ADDENDUM NO. 1

**North Central High School Outdoor Athletic Facilities - Phase 4b –Main Package
1801 East 86th Street
Indianapolis, IN 46240**

ADDENDUM NO. 1.4B

PREPARED BY SCHMIDT ASSOCIATES FOR:
NORTH CENTRAL HIGH SCHOOL RENOVATION
WASHINGTON TOWNSHIP, M.S.D. OF

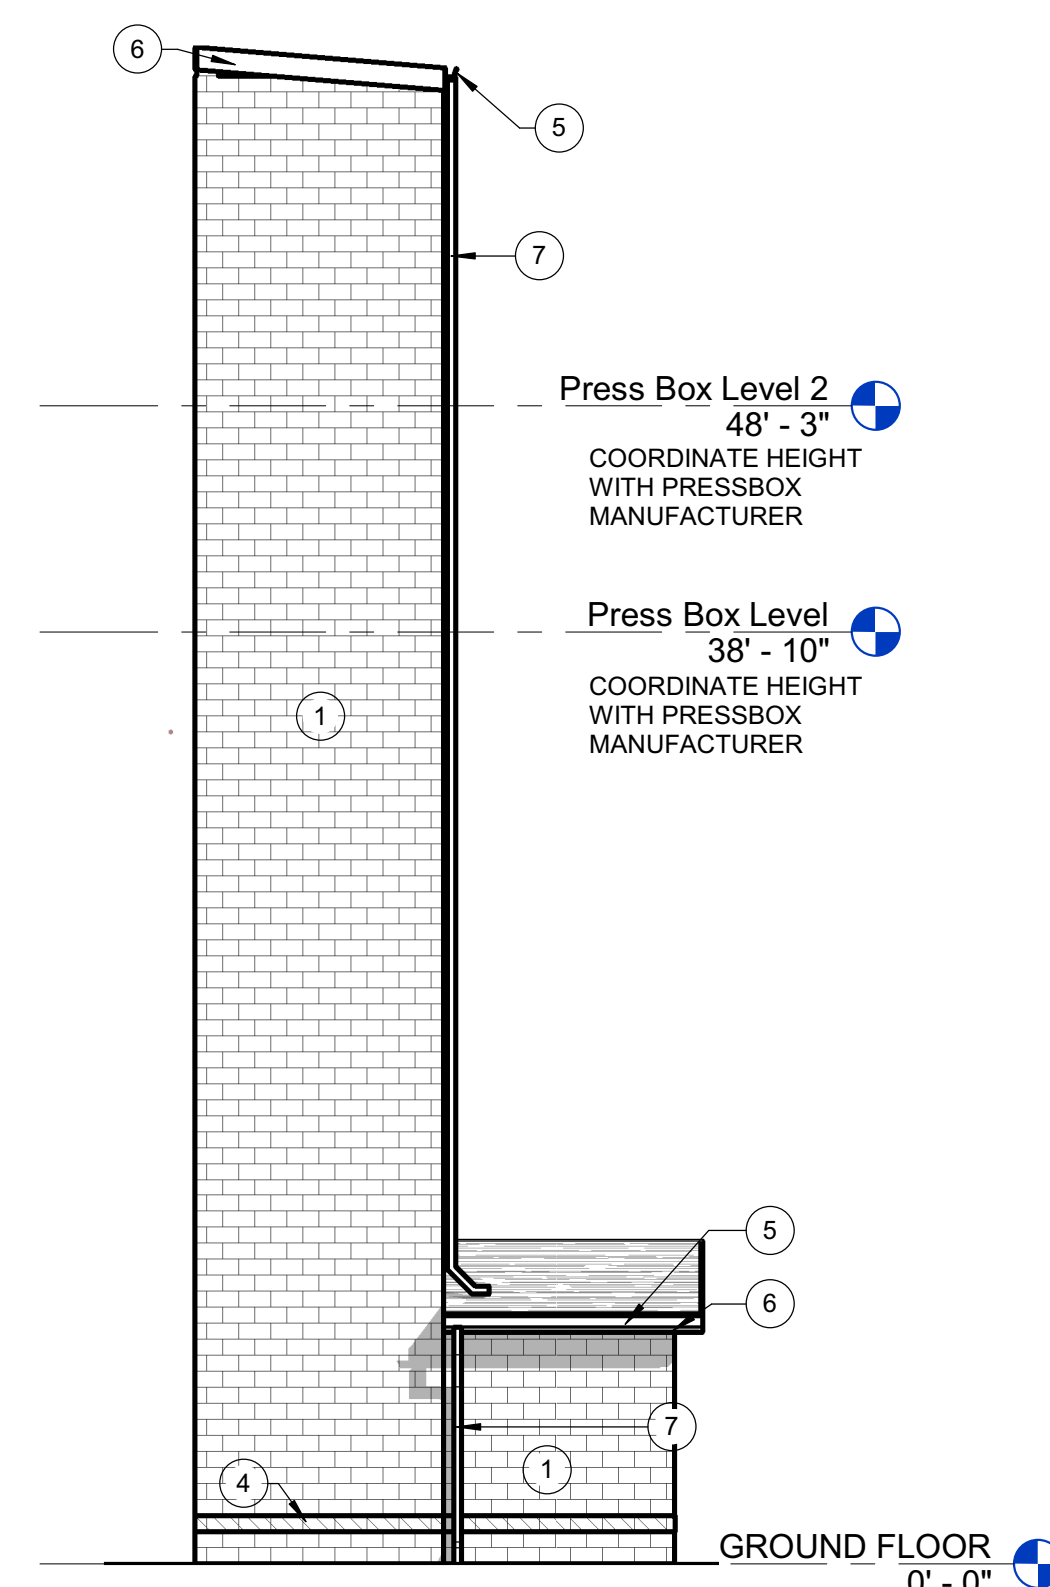
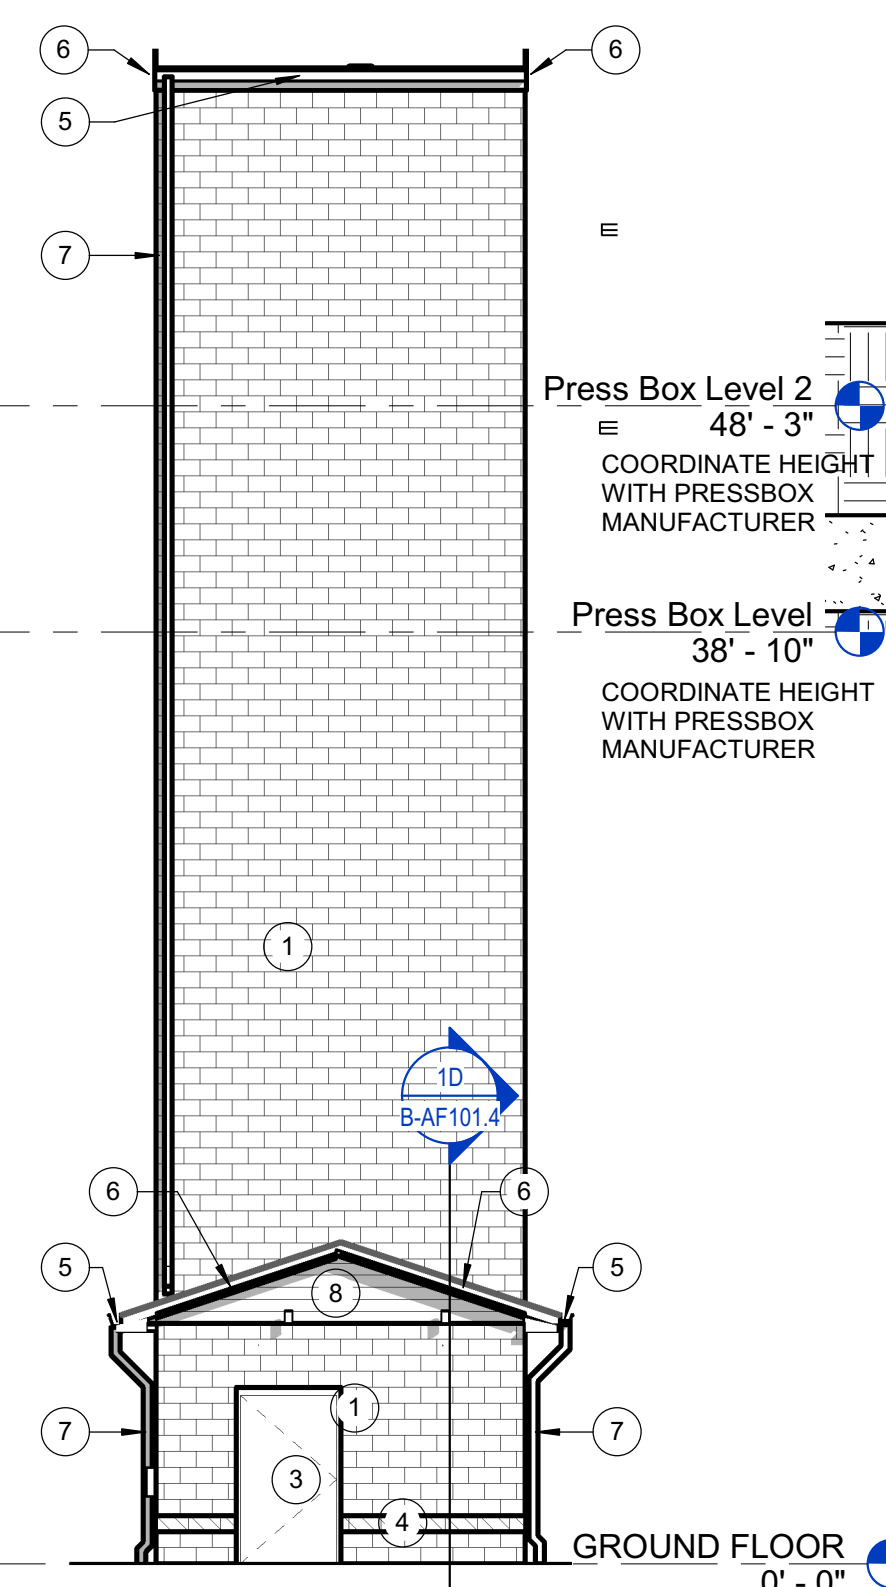
1. DELETE AND REPLACE Building Elevation Note 9 in its entirety and replace with the following:
"074213.13 - BI-PARTING STEEL SLIDING BARN DOOR AND TRACK SYSTEM. DOOR TO HAVE METAL WALL PANELS TO MATCH SALT BARN WITH BORDER TRIM - COLOR AS SELECTED BY ARCHITECT. PROVIDE STANDARD METAL COVER OVER TRACK - COLOR AS SELECTED BY ARCHITECT. TRACK TO BE EASY-TRAK BY HARVARD PRODUCTS, SIZED APPROPRIATELY FOR DOOR PANEL SIZES AND OPERATION. PROVIDE GUIDES AT BOTTOM OF DOOR AND HANDLES. HASP AND PADLOCK PER 087100"
